CITY OF ALBUQUERQUE

Re: Quaker Heights Townhomes
99999 Quaker Heights Pl. NW
Traffic Circulation Layout
Engineer's Stamp 02-16-23 (F11-D020A)

Based upon the information provided in your submittal received 03-03-23, the above referenced plan cannot be approved for Building Permit until the following comments are addressed:

TCL

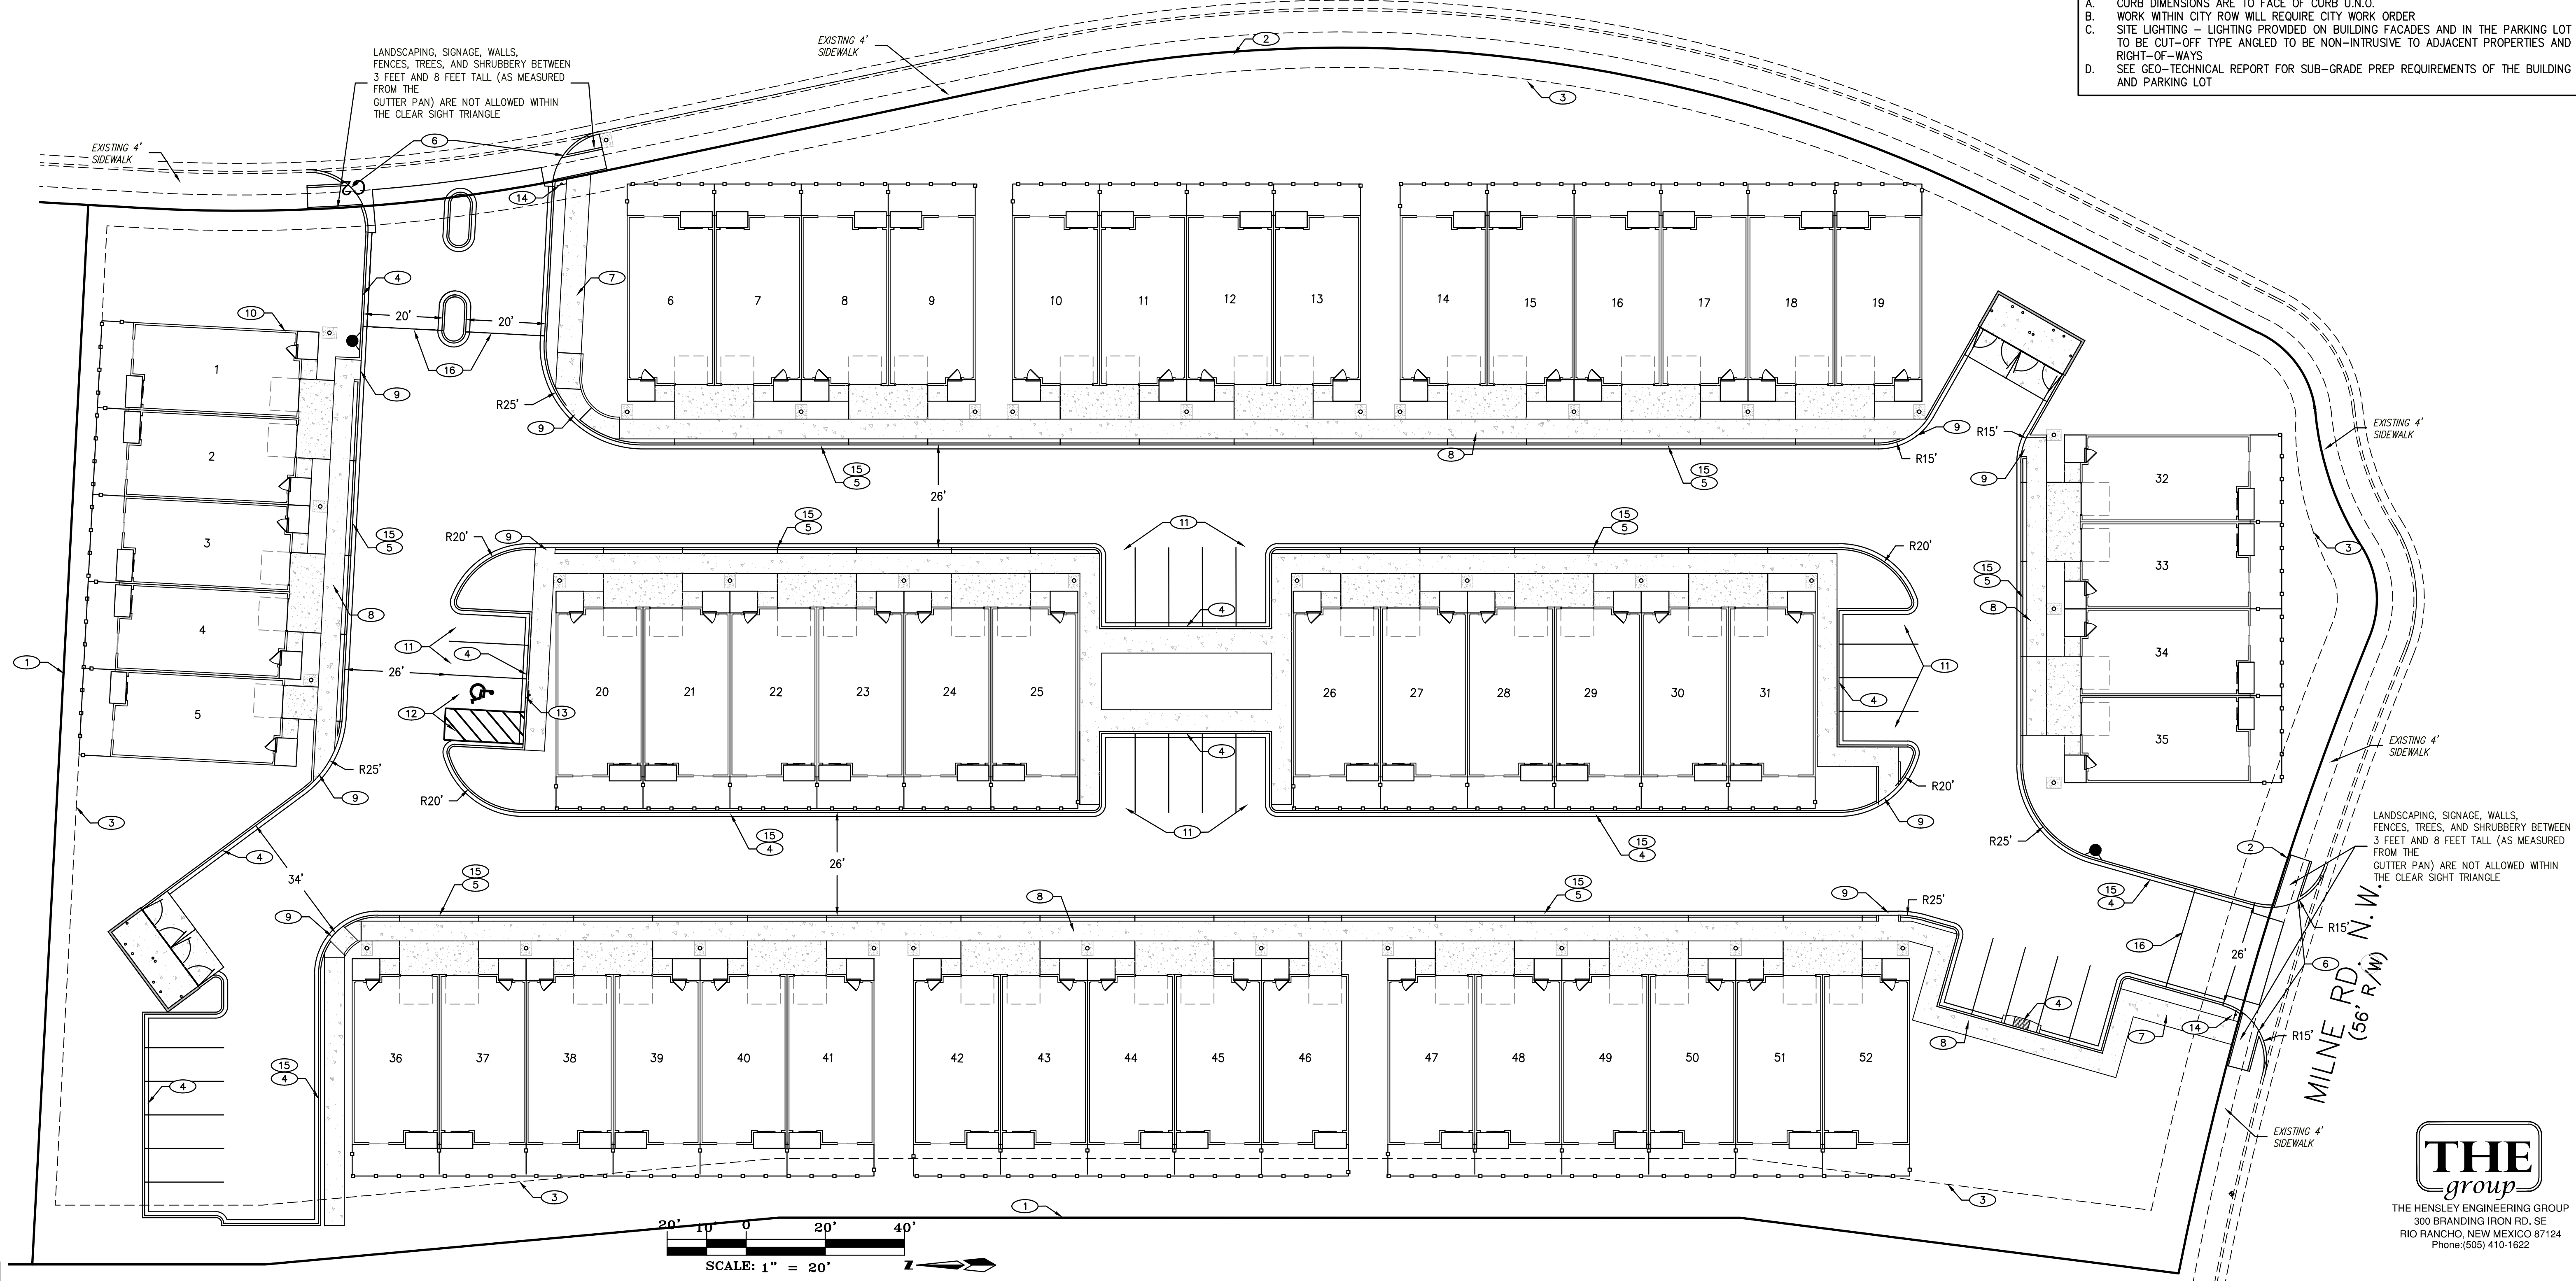
1. Identify all existing access easements and rights of way width dimensions.
2. Per new city requirements a minimum 5' wide public sidewalk must be built from property line to property line along Quaker Heights Pl. and Milne Rd.
3. Please check with Code Enforcement if Motorcycle and Bicycle parking spaces are required.
4. Provide ADA parking space dimensions.
5. Please define the ADA pathway from the ADA parking aisle to the building entrance by labeling of flush or ramps.
6. ADA curb ramps must be updated to current standards and have truncated domes installed.
7. A 5 ft. keyway is required for dead-end parking aisles at the north west side of the site.

8. Refuse vehicle maneuvering shall be contained on-site. The refuse vehicle shall not back into the public right of way.; provide a copy of refuse approval.
9. Provide a copy of Fire Marshal approval.

NM 87103

10. It is not apparent what type of pavement surface is being proposed. A hard driving surface will be required as part of this proposed project for parking area and drive aisles.

4 REFUSE ENCLOSURE
Scale: 1/4"=1'

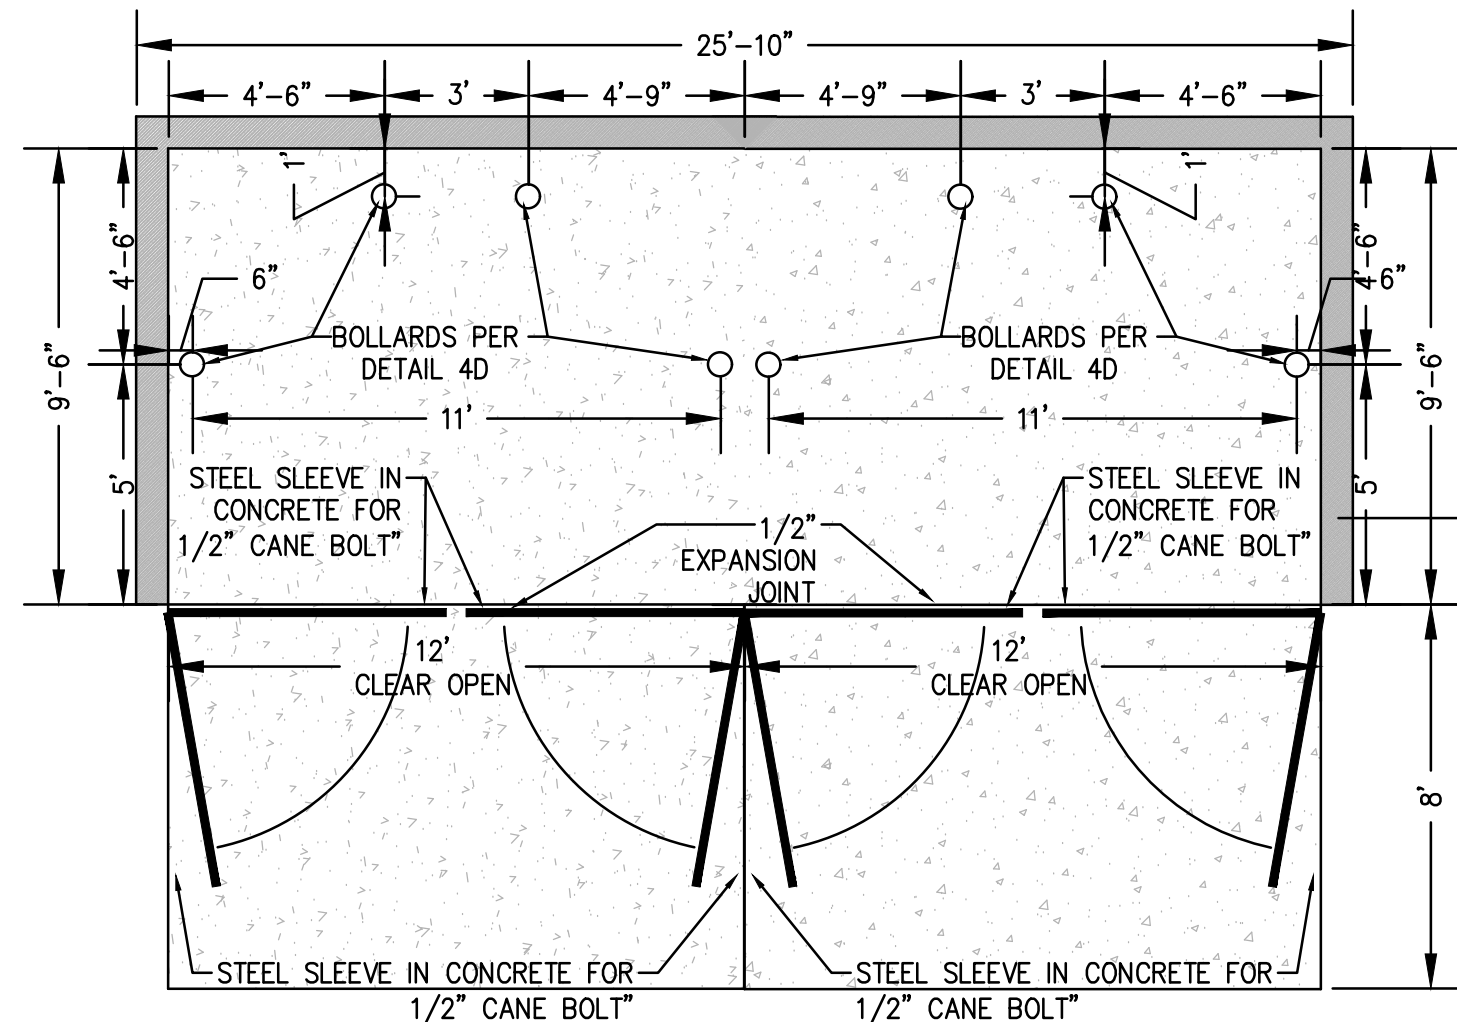
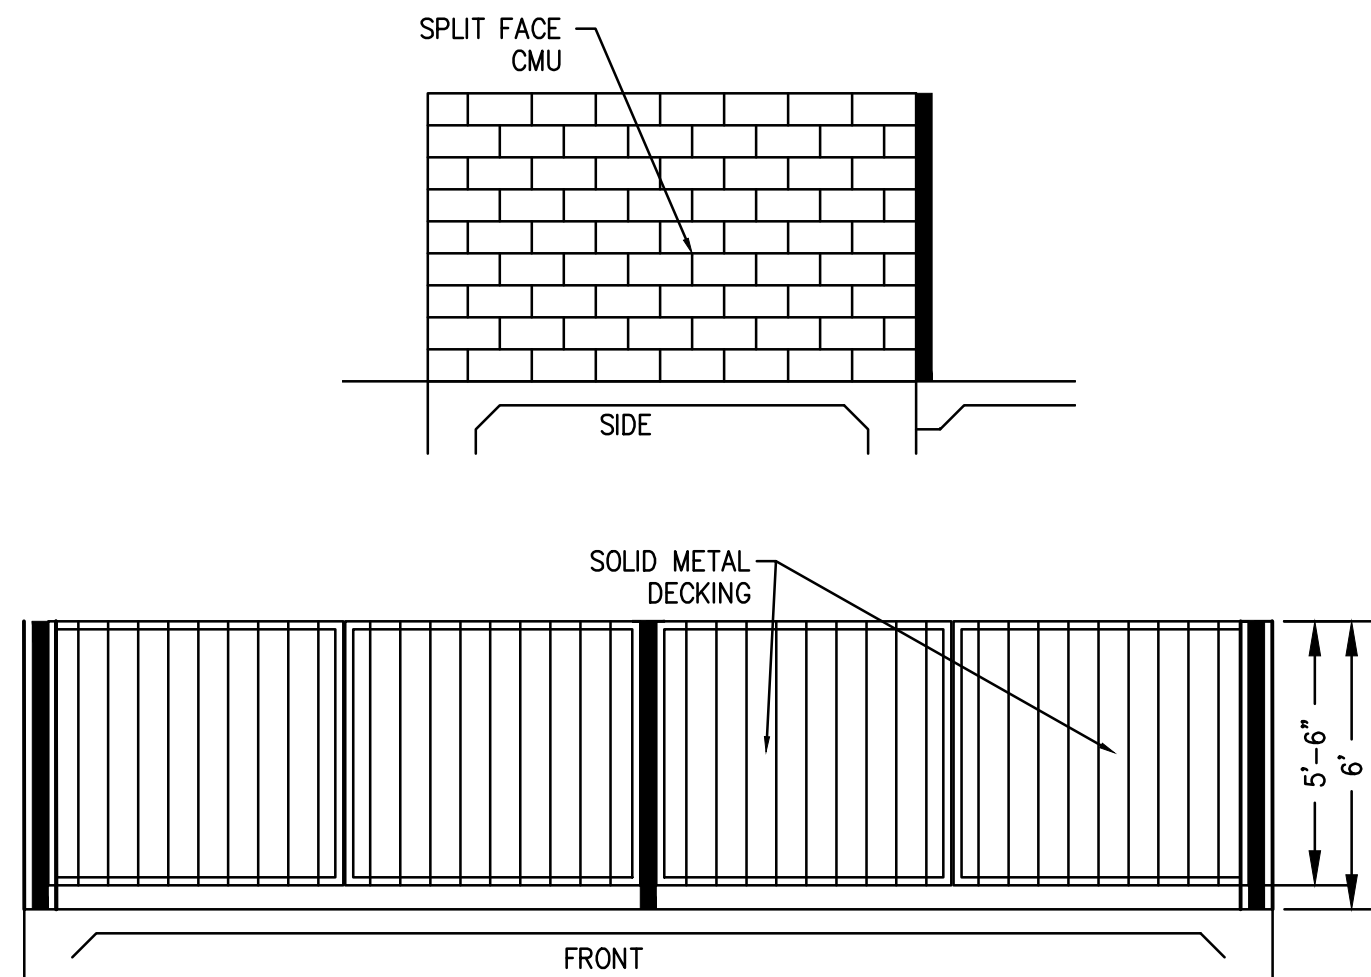
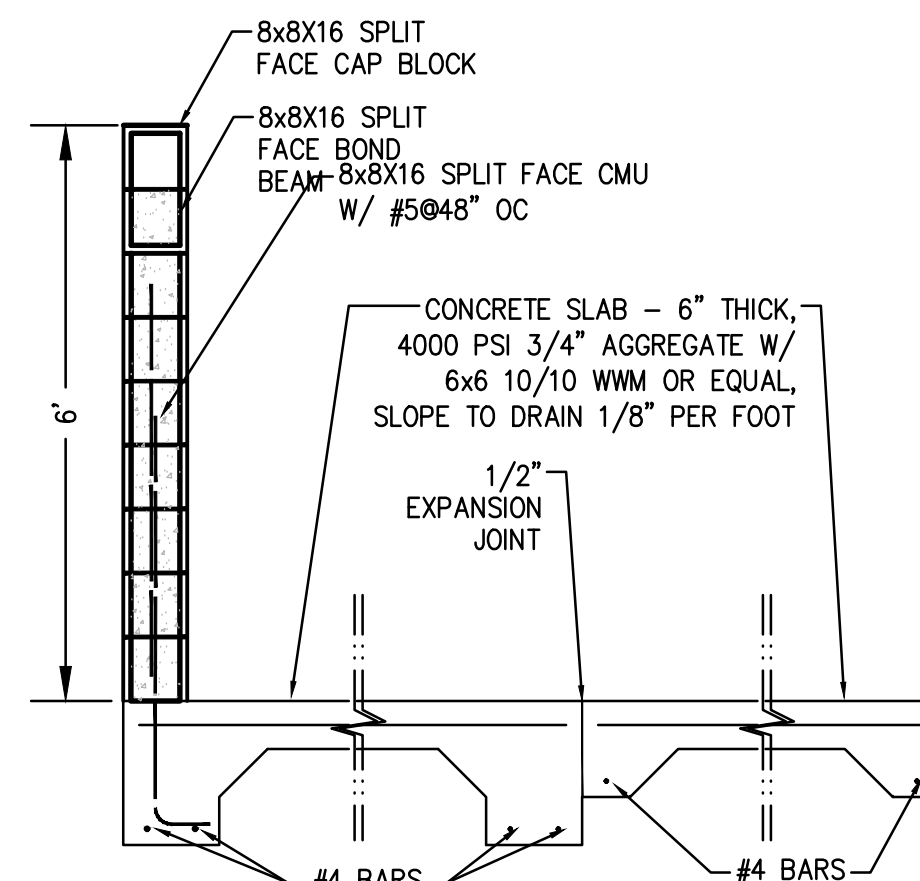
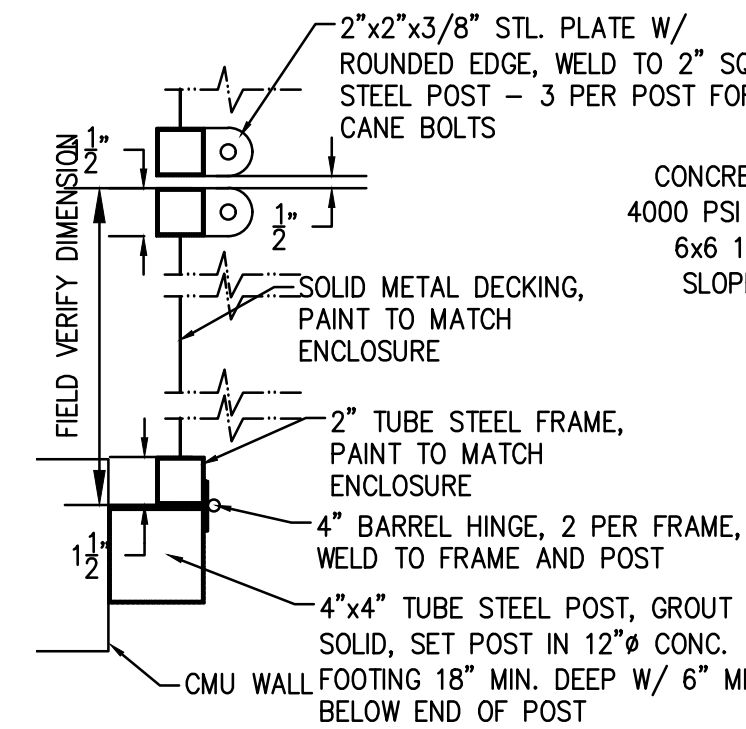
11. Please remove Refuse Enclosure details from Transportation details sheet.
12. Please specify the City Standard Drawing Number when applicable.
13. Please add a note on the plan stating "All improvements located in the Right of Way must be included on the work order."
